Type 1 Power Parameter Adjustments

This presentation proposes increasing Type 1 MPD 1U power to 4W and details the changes needed to power parameters

Table 189-1—System power types

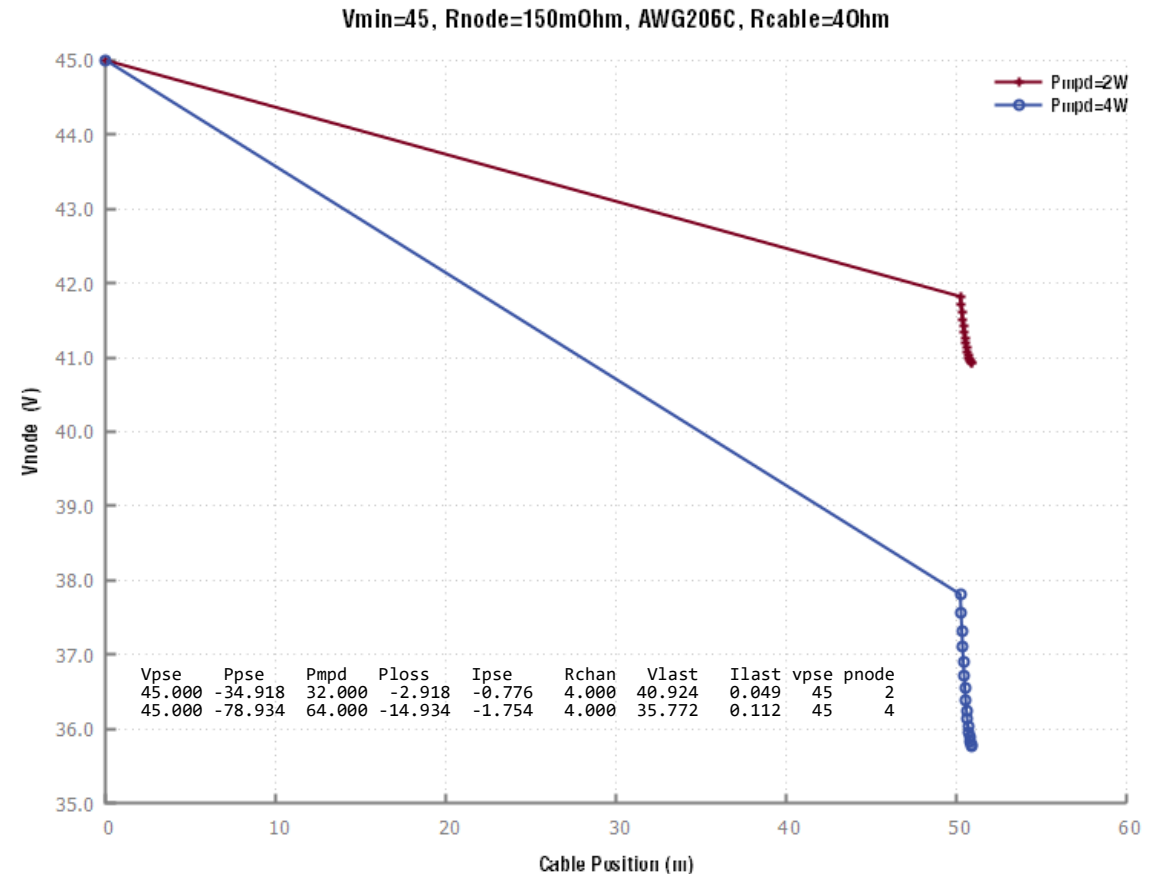
Adjust power parameters while keeping last node voltage above ~35V

30 V Max MPSE (Type 0)	50 V Max MPSE (Type 1)	Units
V _{MPSE} max	30	50	V
V _{MPSE} min	21.6	45	V
V _{MPD} min	16	34 35.5	V
I _{MPSE} min	1100	1000 1760	mA
P _{MPSE} min	23.76	45 78.75	W
P _{MPD_IU} max	1.1	2 4	W

Edits Satisfy D2.2 Comments:
52, 53, 59, and 59
